**Road Safety Audit**  
**Stage 1/2**  
**for**  
**ACCESS TO PROPOSED MIXED USE DEVELOPMENT**  
**AT**  
**CARRIGALINE, CO CORK**

**Reference:** RSM/MOB/121021/CARRIGALINE RSA1-2

<b>Client</b>	HLCE Limited
<b>Project Title</b>	Access to Mixed Use Development, Carrigaline, Co Cork
<b>Document Title</b>	Stage 1/2 Road Safety Audit
<b>Document Ref.</b>	RSM/MOB/121021/CARRIGALINE RSA1-2
<b>Status</b>	FINAL

**Figure 7: Levels and details unknown in Public Amenity Area**

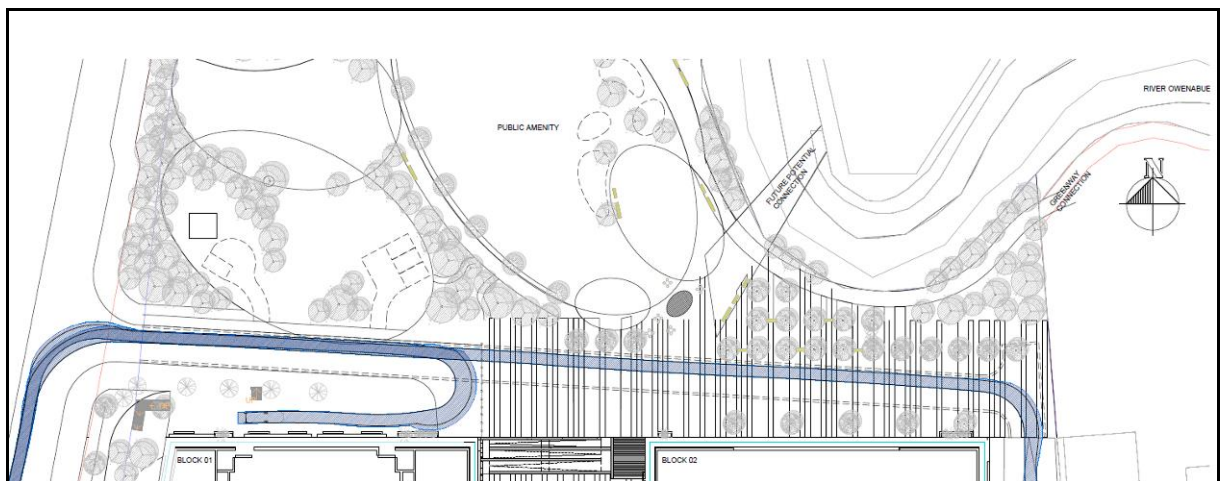
There were no long or cross sections provided for the proposed roads. A large portion of the northern section of the site will be used for public amenity, adjacent to the River Owenabue, however there were no details provided for proposed surfaces and gradients on footways and VRU routes to determine suitability for all road users, including those who are mobility or visually impaired.

1. Detailed design should include vertical design and long and cross sections, and provision should be made for a relatively level dwell area at the proposed site access for a distance of 15m back from the channel line.
2. Detailed design should include details of any proposed embankments along the western site perimeter, and details of all gradients and crossfalls on roads and surfaces to be used by traffic and VRUs, including within the public amenity area at the north of the site.

3. A minimum crossfall of 2.5% should be provided on the access link, or the longitudinal profile should be a minimum 2% to minimise the risk of standing water. A minimum crossfall of 2.5% should also be provided on footways.
4. Detailed design should include kerb design to include detailed of all dropped kerbs and full height kerbs within and surrounding the site. All kerbs on pedestrian desire lines to be flush with the surrounding surface or have a maximum upstand of 6mm.

2.1.6	Yes	Yes	These issues will be address at detail design stage prior to tender issue.	
2.1.7	Yes	Yes	These issues will be address at detail design stage prior to tender issue.

**Figure 8: Proposed Layout at Site Access**

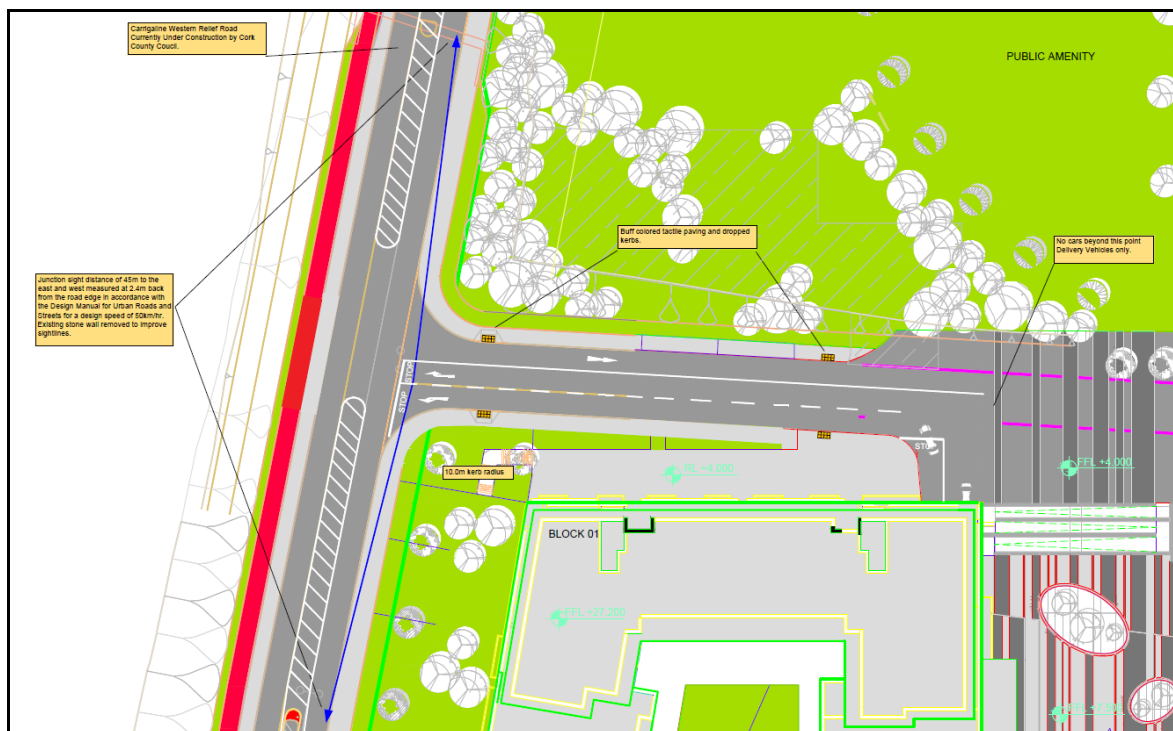
The TTA for the site indicates turning movement proportions and anticipated Queues during AM and PM peak hours for the development site, and the layout plan indicates provision for a ghost island junction on the CWRR, however there is no provision for suitable reservoir length for queuing vehicles including deceleration length, to minimise obstruction to through traffic and potential for increased rear shunt collision risk. The junction has also been configured with two egress lanes at the proposed stop line on the minor road, which will increase the number of simultaneously turning traffic streams at the junction, and presents an increased risk of right-angled collisions and pulling out type incidents due to waiting vehicles in the adjacent lane on the minor road obstructing clear visibility to and from oncoming vehicles.

The swept path analysis provided for the proposed access junction showed right turning vehicles only entering. Left turning manoeuvres to and from the site have not been shown, which are typically the most constrained movement, particularly on a layout where there will be two lanes of egressing traffic waiting to turn out, which increases the likelihood of obstruction for entering vehicles.

1. The layout should ensure that the total demand for right turners into the site is satisfied by the proposed layout, with suitable right turn reservoir length, and that traffic queuing to enter the development site will not obstruct the movement of through traffic on the CWRR.

2. The minimum length of right turn reservoir should be provided in accordance with the relevant standards for ghost island junction design, to include queuing length, deceleration length, taper and turning length, taking into account approach speeds and forward visibility from each direction, with visibility to be clear and unobstructed at all times in accordance with traffic speeds.

3. The number of exit lanes should be reduced to one to minimise the number of conflicting movements and to minimise the crossing distance for pedestrians. Vehicles waiting to turn out of the minor road must not obstruct entry for other vehicles, including emergency access.

2.1.8	Yes	Yes	These issues will be address at detail design stage prior to tender issue.	
2.2.1	Yes	Yes	These issues will be address at detail design stage prior to tender issue.

**Figure 10: Proposed Ramps and steps within Site**

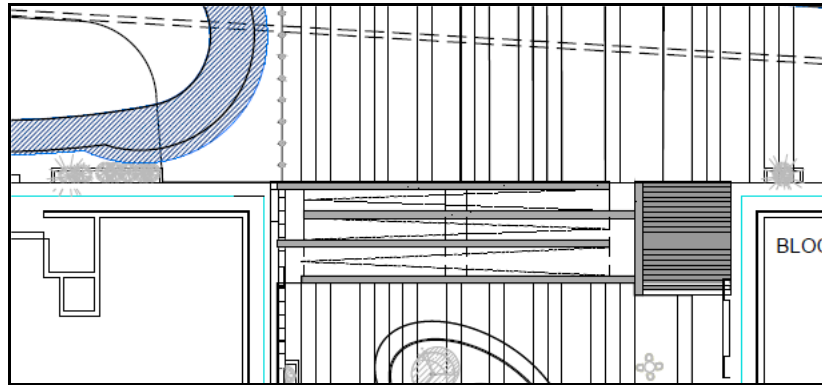
**2.3.1.2** Ramps and steps have been shown at a number of locations within the site, however details have not been provided for ramps to ensure widths and gradients are suitable for all anticipated road users. Tactile paving has not been shown to the top and bottom of steps to alert visually impaired pedestrians to the presence of the hazard.

1. All ramps throughout the scheme should have a maximum gradient of 1:20 (preferable) or 1:12 (absolute maximum over short distances only) at all locations. An alternative means of access for wheelchair users must be provided in all locations where steps have

been provided and where there is no ramp, or where ramp gradients of 1:20 or greater are provided, with a total ramp rise greater than 2m.

2. Ramp widths and layout should comply with the requirement of Technical Guidance Document M, Access and Use (2010) with the minimum unobstructed width between handrails to be not less than 1200 mm, and 1500mm between the walls, with wider ramps to be provided for shared use with cyclists, or where a high demand for access by buggy/double buggy users may arise.
3. Corduroy tactile paving should be provided at the top and bottom of all steps throughout the site and configured in accordance with 'Guidance on the use of Tactile Paving Surfaces'.

2.3.1.2	Yes	Yes	These issues will be address at detail design stage prior to tender issue.	
2.3.1.3	Yes	Yes	These issues will be address at detail design stage prior to tender issue.	
2.3.1.4	Yes	Yes	These issues will be address at detail design stage prior to tender issue.	
2.3.2	Yes	Yes	These issues will be address at detail design stage prior to tender issue.	
2.4.1	Yes	Yes	A public lighting design has been prepared as part of the planning application..	
2.4.2	Yes	Yes	A detail schedule of signage and road marking will be produced at detail design stage prior to tender.

**Figure 13: Vehicular Movements on Pedestrian Access**

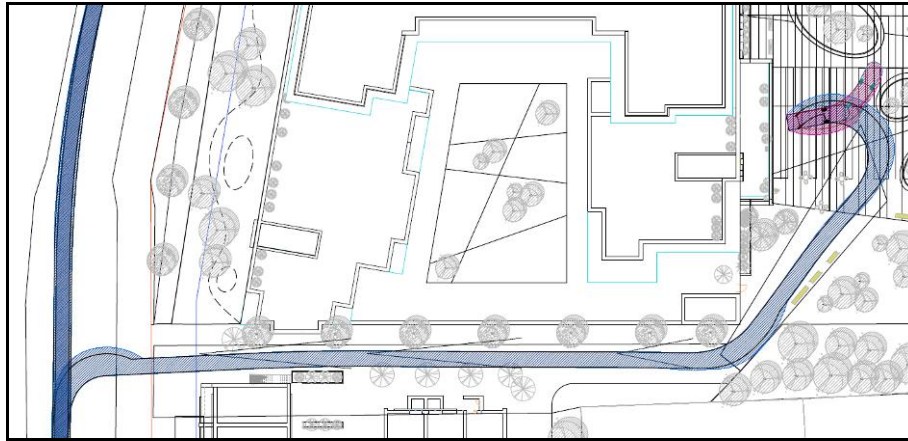
**2.3.1.3** A pedestrian access has been shown at the southern section of the site which includes ramps and steps, however swept path analysis has been provided to demonstrate vehicular access at this location also, where conflict may arise. Pedestrians are also likely to be circulating within the access route to and from the delivery area to the east of the site, where conflicts may also arise, particularly as HGVs have limited visibility and blind spots.

1. Pedestrian movements should be segregated from HGV and vehicular movements where possible throughout the site.
2. All routes to be used by vehicles should have suitable gradients, and provision should be made for suitable dropped kerbs where necessary at all locations where vehicular access is required, including for emergency vehicle access, with clear signage for the latter to ensure routes are not obstructed by other vehicles.

**Figure 14: Details for Greenway Connection & Cyclist Connectivity Not known**

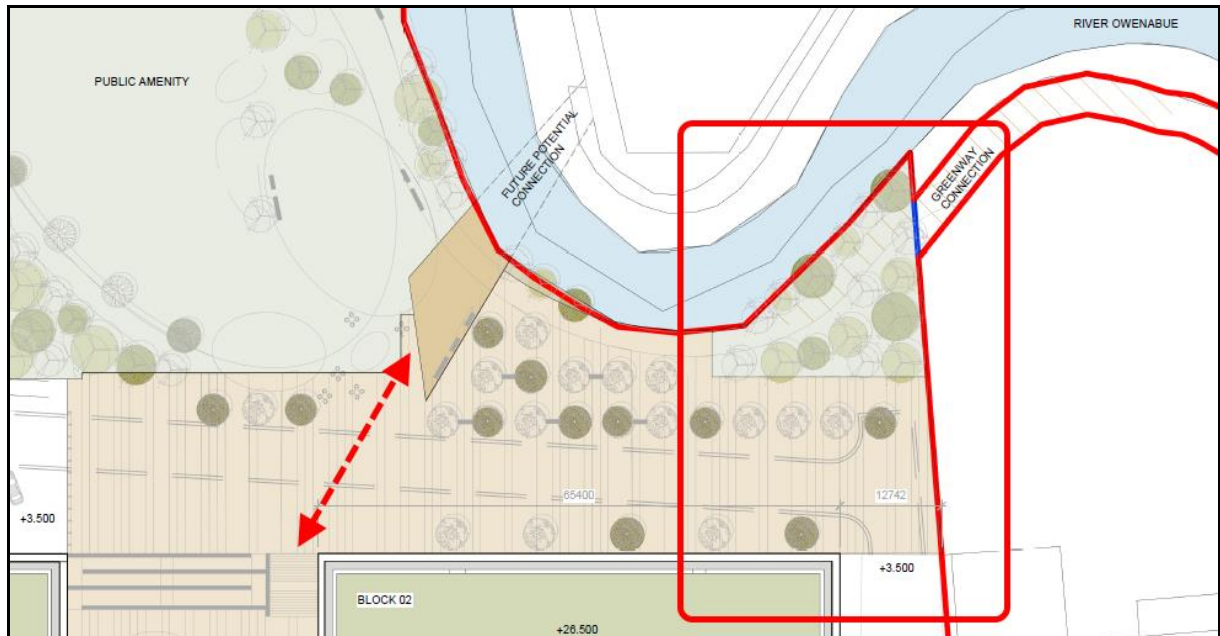
No information has been provided on likely cyclist demand and activity to and from the site, and there was no cycling activity observed adjacent to the site at the time of the site visit. The design includes provision for a significant number of cycling parking spaces, however the proposed routes to and from the bicycle parking areas are unclear. There are no dedicated cycling routes or facilities shown, and cyclists would be expected to share road space with motorised vehicles where the risk of conflict is higher. The widths of the proposed footways throughout the site and surrounding the site are insufficiently wide for

shared use between cyclists and pedestrians. The layout plans show provision for a Greenway connection to the northeast side of the site along the southern bank of the river, however there is no provision for connectivity to the hard surface areas. Cyclists will also be brought out into an area where vehicles will be reversing and turning, as a turning head has been shown, as indicted on figure 14. Future potential connection over the river has also been shown, however it is unclear how cyclists will access the southern section of the site as the ramp width shown in figure 4 immediately west of the steps appears too narrow.

1. Likely cyclist demands, desire lines and volumes should be examined within and on all approaches to the site to take into account issues raised in this Stage 1/2 RSA report, with safe continuous and unobstructed facilities provided to cater for anticipated cycling demands, inclusive of shared off road facilities wherever possible, with a minimum 3m width, to minimise the risk of pedestrian and cyclist conflict.
2. Provision should be made for suitable transition kerbs to facilitate safe access between on and off-road facilities and proposed bicycle parking spaces within the site, and gradients on all routes to be used by cyclists should be a maximum 3%.

3. Detailed design should include provision for suitable connectivity to the Greenway and proposed cycling network long the CWRR. Cyclists should not be brought out into areas where vehicles will be turning and reversing.

**Figure 15: No provision for signs to distinguish Service Vehicle Access**

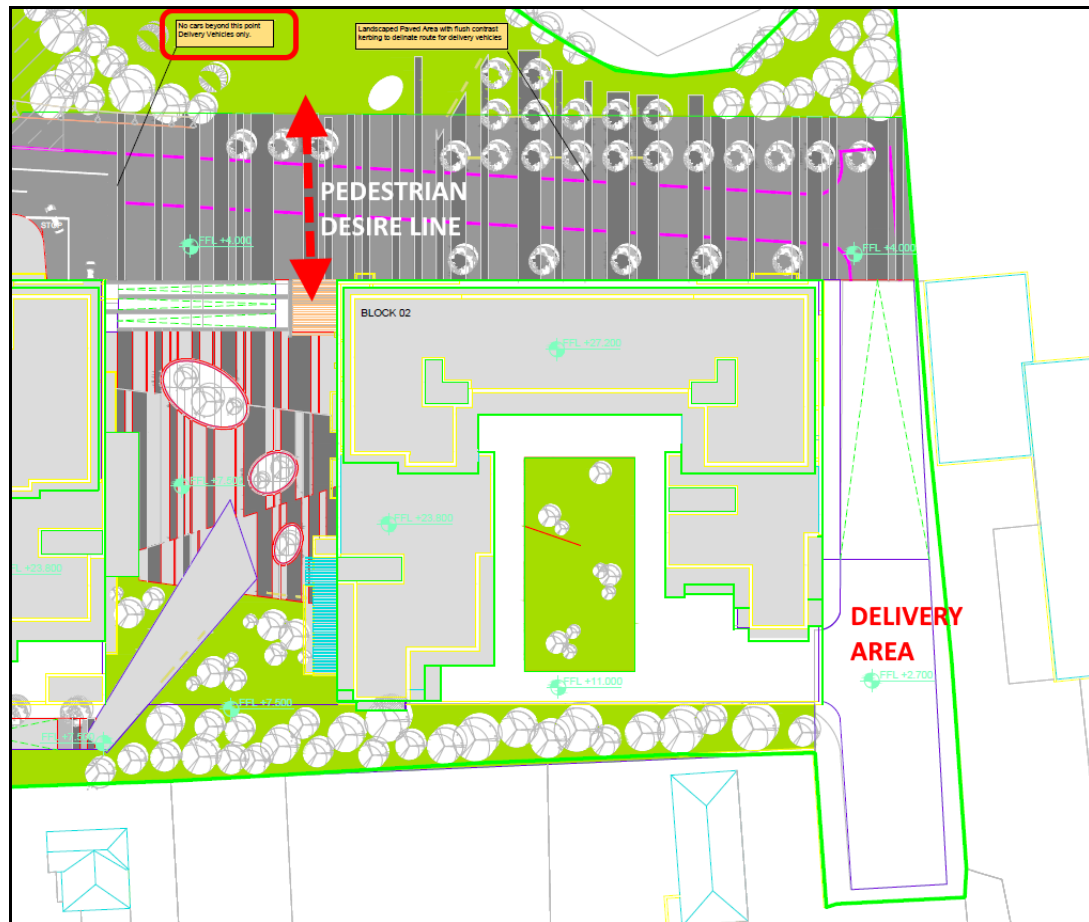
There was no signing and lining schedule provided for the proposed signs and road markings, however the design layout includes for stop lines and markings at the proposed site access and at the access to the basement car parking area. No provision has been made for associated signage in accordance with the requirements of the Traffic Signs Manual. There is no provision for reduced speed limit and slow zone signage, parking restrictions and no signs or guidance regarding the restriction of access for delivery vehicles only to the eastern area of the site, where a high pedestrian desire line should be anticipated.

1. A signing and lining schedule should be produced at detailed design stage, to take into account all issues raised in this Stage 1/2 RSA report, to include provision for standardised road markings and signage in accordance with the Traffic Signs Manual.
2. All signs should be posted in full view of motorists in a safe location with a minimum offset of 450mm from the sign face to the carriageway edges. The lowest edge of all signs should be set at a height of 2.1m or higher over footway and at 2.4m or higher over a surface which may be used by cyclists.
3. All road markings and signage to be highly reflective material to ensure visibility during the hours of darkness.
